**Palo Verde
Nuclear Generating Station**
P.O. Box 52034
Phoenix, AZ 85072
Mail Station 7605
Tel 623.393.6491

102-07691-MLL/MDD
May 18, 2018

Subject: **Palo Verde Nuclear Generating Station Units 1, 2, and 3
Docket Nos. STN 50-528, 50-529, and 50-530
APS Response to Request for Additional Information for
Risk-Informed Completion Times**

**APS Response to Request for Additional Information for
Risk-Informed Completion Times**

EPRI HRA Calculator Decision Tree Figure 2-1

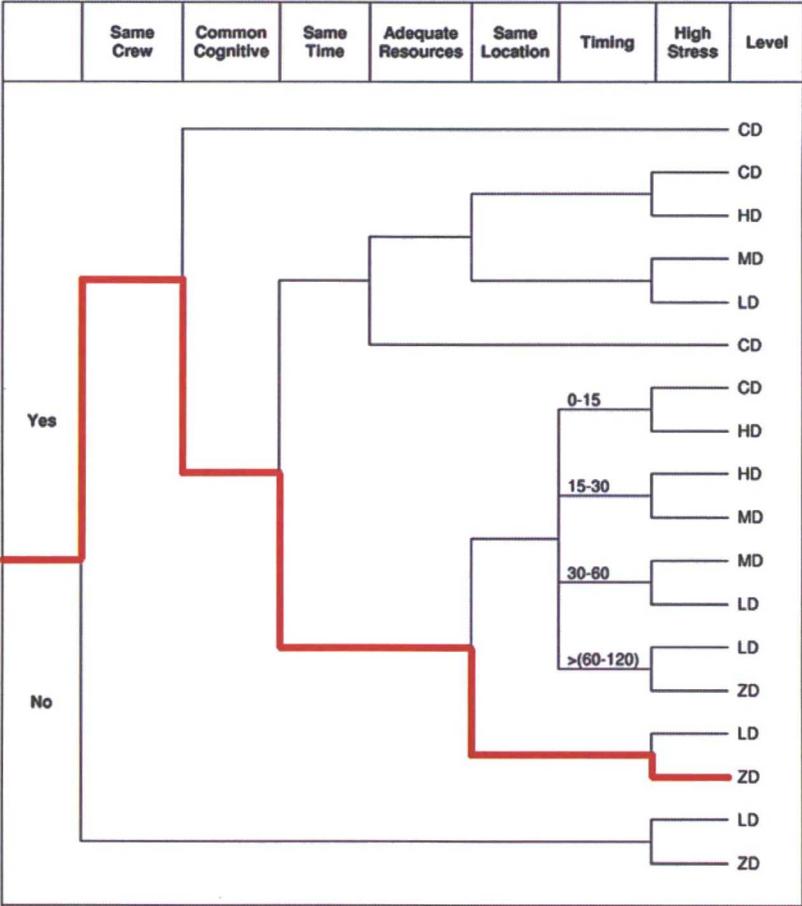
- c. Attachment 13, Table A13-1, states:

"The flood [human reliability analysis] HRA dependency analysis did not include large early release specific [human failure events] HFEs. HFEs specific to large early releases (i.e., post-core damage operator actions) are generally performed several hours after the initiating event occurs. No dependency between early and late operator actions. There is no impact on the model."

Although operator actions may be performed several hours after the initiating event occurs, that does not necessary imply that there is no dependency between early and late operator actions for an internal flood event. Please explain further your conclusion regarding these assumed HRA dependencies.

- c. Figure 2-1 shows the decision tree from the Electric Power Research Institute (EPRI) HRA Calculator utilized to determine HFE dependence. For example, dependency between early and late operator actions for an internal flood event can be represented by the highlighted tree path leading towards zero dependence. The HFEs represents same crew, different common cognitive, at different times, different locations and moderate stress level. All HFE dependency analyses are evaluated in accordance with NUREG/CR-1278, *Handbook of Human Reliability Analysis with Emphasis on Nuclear Power Applications*, published in August 1983, and meet all requirements found in the American Society of Mechanical Engineers/American Nuclear Society (ASME/ANS) RA-Sa-2009, *Standard for Level 1/Large Early Release Frequency Probabilistic Risk Assessment for Nuclear Power Plant Applications*, (Addendum A to RA-S-2008), as endorsed by RG 1.200, Revision 2.

1JSIBUV0675 Common Cause Modeling
Figure 3-1

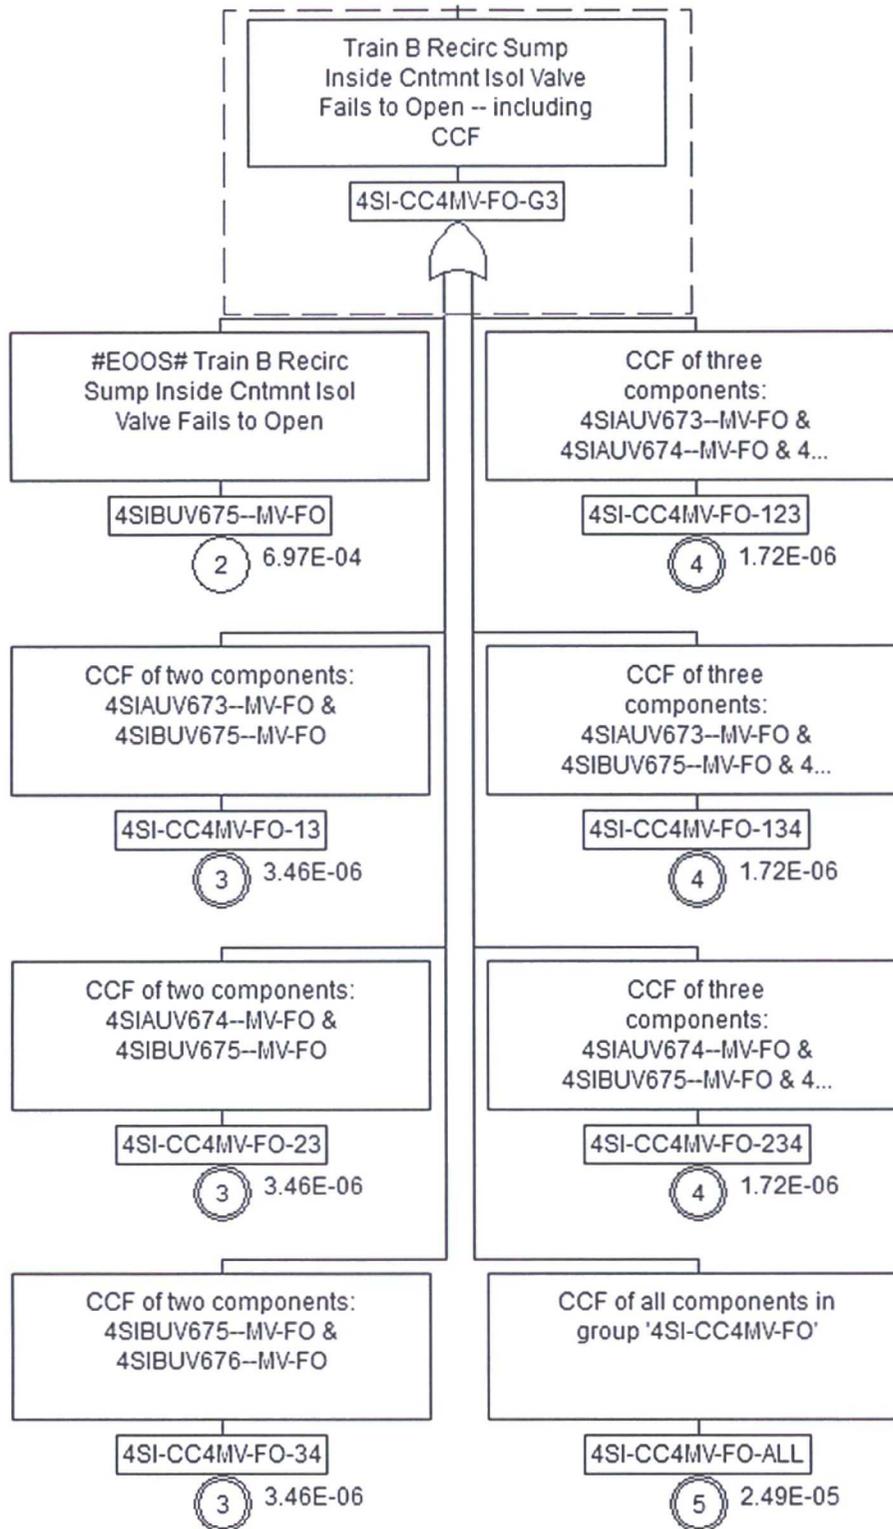
According to RG 1.177, if a component from a CCF group of three or more components is declared inoperable, the CCF of the remaining components should be modified to reflect the reduced number of available components in order to properly model the as-operated plant.

- a. Please explain how CCFs are included in the PRA model (e.g., with all combinations in the logic models as different basic events or with identification of multiple basic events in the cut sets);
- b. Please explain how the quantification and /or models will be changed when, for example, one train of a 3X100 percent train system is removed for preventative maintenance and describe how the treatment of CCF meets the guidance in RG 1.177 or meets the intent of this guidance when quantifying a RICT.

- a. Common cause failure is modeled with basic events for the combinations of components in the respective fault tree. An example is the four motor operated Safety Injection containment sump suction valves (CCF Group 4SI-CC4MV-FO). This group has eleven basic events accounting for the various combinations of components for CCF. For an individual valve fault tree, all CCF combinations with that valve are placed under the gate in the fault tree. An example with valve 1JSIBUV0675 is provided in Figure 3-1.
